DOCKET NO: 50-286

FACILITY: Indian Point Nuclear Generating Unit 3

SUMMARY OF MEETING HELD ON OCTOBER 30, 1973 TO DISCUSS THE INDIAN POINT 3 TECHNICAL SPECIFICATIONS, THE STATUS OF THE DIESEL COOLING CONCERN, AND A NEW PROBLEM - TURBINE OVERSPEED

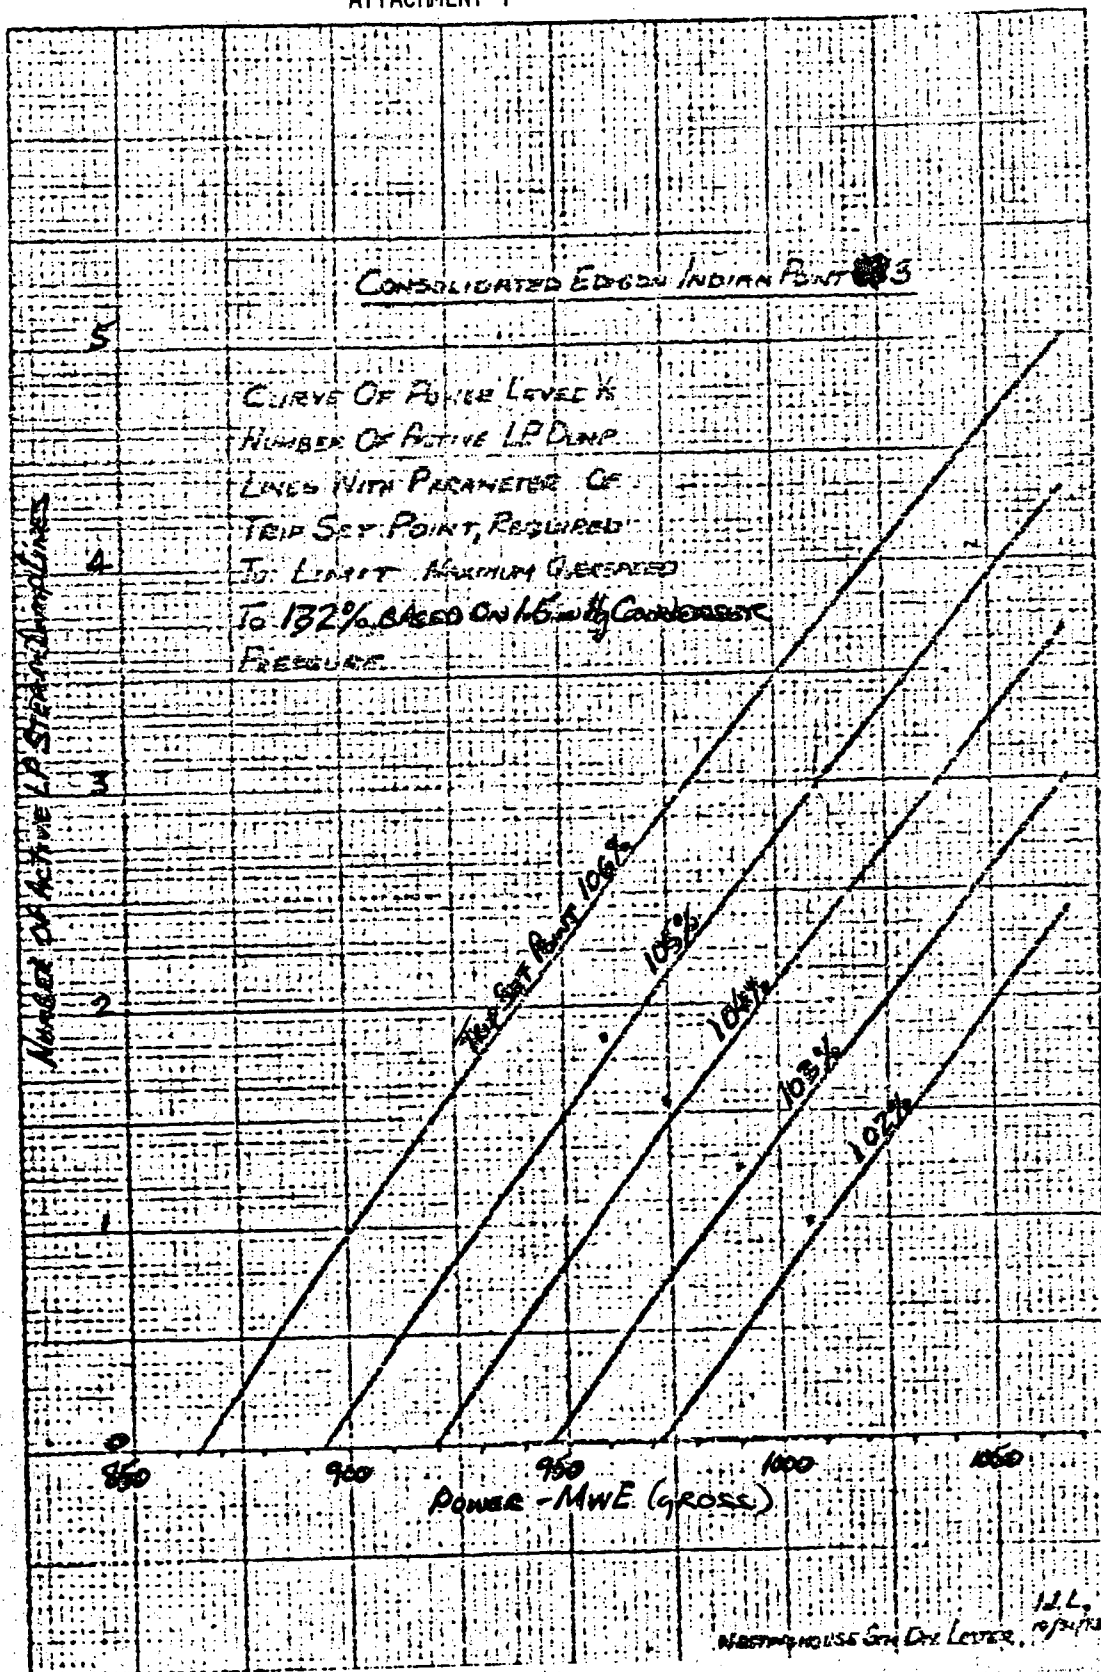
The proposed technical specification that relates power level to turbine set point and the number of operable dump valves is attached. These curves will be verified by the test data. A list of attendees is also attached.

The applicant has proposed and the staff has accepted the use of technical specification limits to reduce the power level and/or trip set point until the modifications are installed.
